World Forum for Harmonization of Vehicle Regulations**Working Party on Passive Safety****Sixty-eighth session**

UN Regulation No. 17 (Strength of seats)**Proposal for Supplement 1 to the 10 series of amendments to
UN Regulation No. 17 (Strength of seats)****Submitted by the expert from the International Organization of Motor
Vehicle Manufacturers ***

"5.6.2.3. Exception

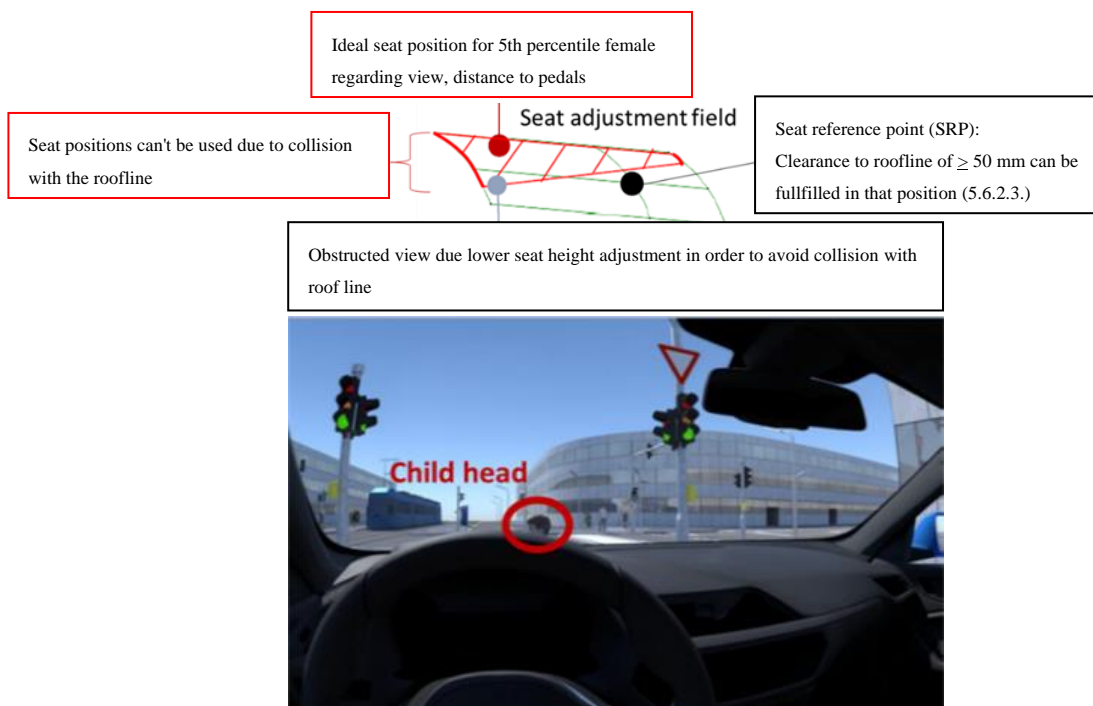
If the interior surface of the vehicle roofline, including the headliner, physically prevents a head restraint, located in the front designated seating position, from attaining the height required by paragraph 5.6.2.1. or 5.6.2.2. of this Regulation as applicable, the gap between the head restraint and the interior surface of the roofline, including the headliner, when measured in accordance with Annex 10. paragraph 2.3.3.1., shall not exceed 50 mm when the head restraint adjusted to its highest position intended for occupant use.

In the case of seats fitted with integrated head restraints that cannot be adjusted in height, if the height required by paragraphs 5.6.2.1. or 5.6.2.2. would result in the head restraint interfering with the roofline in at least one seat adjustment intended for normal occupant use, then the required height needs not be met, provided the clearance in this/these seat adjustment(s) does not exceed [10] mm. If this leads to a gap of more than 50 mm when measured in accordance with Annex 10, paragraph 2.3.3.1., then the head restraint shall conform to the applicable requirements of paragraph 5.6.1.1.2.

However, in no instance shall the height of a head restraint located in a front designated seating position be less than 700 mm when the head restraint is adjusted to its lowest position intended for occupant use."
